**To:** Members of Dublin City Council  
**From:** Dana L. McDaniel, City Manager   
**Date:** April 6, 2017  
**Initiated By:** Vincent A. Papsidero, FAICP, Planning Director  
Logan M. Stang, Planner I  
**Re:** Wyandotte Woods, Section 9 - Final Plat (15-108FDP/FP)

This is a request for approval of a Final Plat to subdivide 9.699 acres into 23 single-family lots and the dedication of public right-of-way for three streets on the north side of Wyandotte Woods Boulevard at the terminus of Kelly Drive.

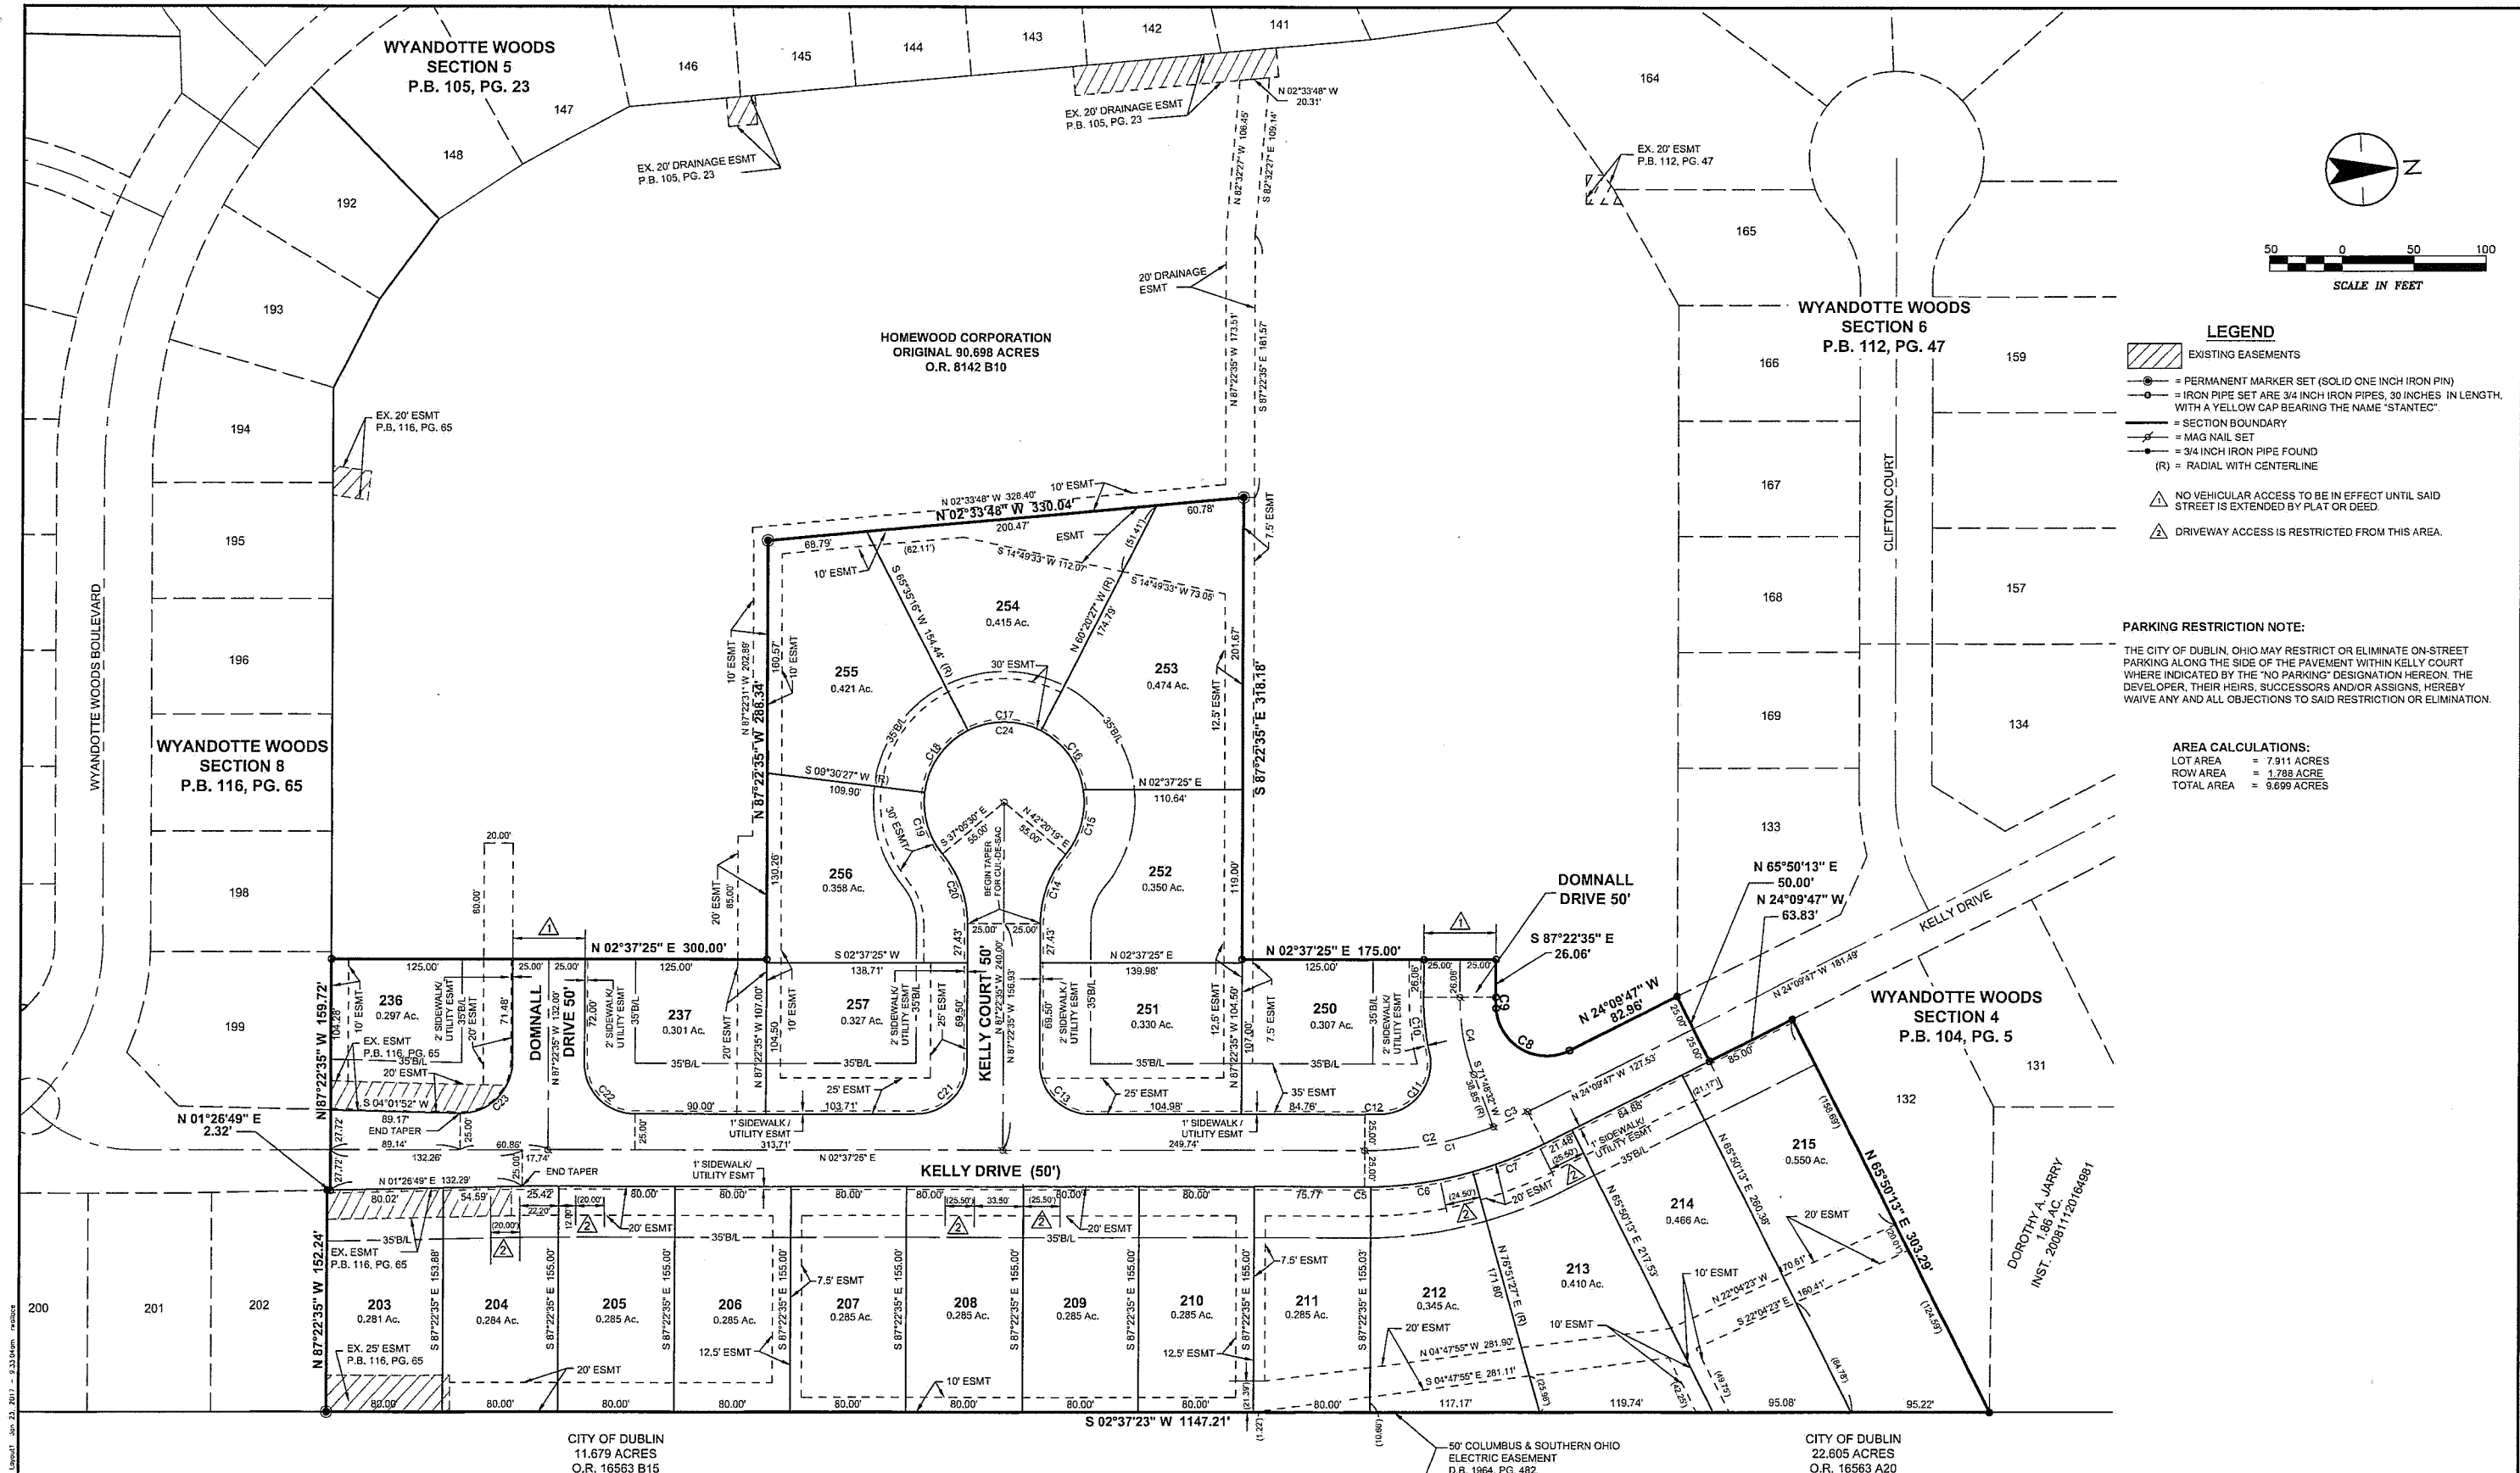
Ms. Husak presented the Final Plat for Section 9. She said the applicant had included a tree preservation zone, noted in green. She said there are no tree preservation zones whatsoever within Wyandotte Woods and the Plat does not include any language for what the definition of a tree preservation zone would be nor does the City have such language in the Subdivision Regulations or the Zoning Code. She said the applicant has been asked to remove that zone from the Plat. She presented the Final Plat for Section 10. She said Staff has assumed that as this application moves forward that it would get approved by City Council potentially as two separate actions.

- 1) That the applicant revise the tree protection zone along Lots 211 to 215 to a No-Disturb Zone prior to City Council submittal; and
- 2) That the applicant ensures that any minor technical adjustments to the plat are made prior to City Council submittal.

The applicant has met and addressed both conditions prior to filing for City Council review.
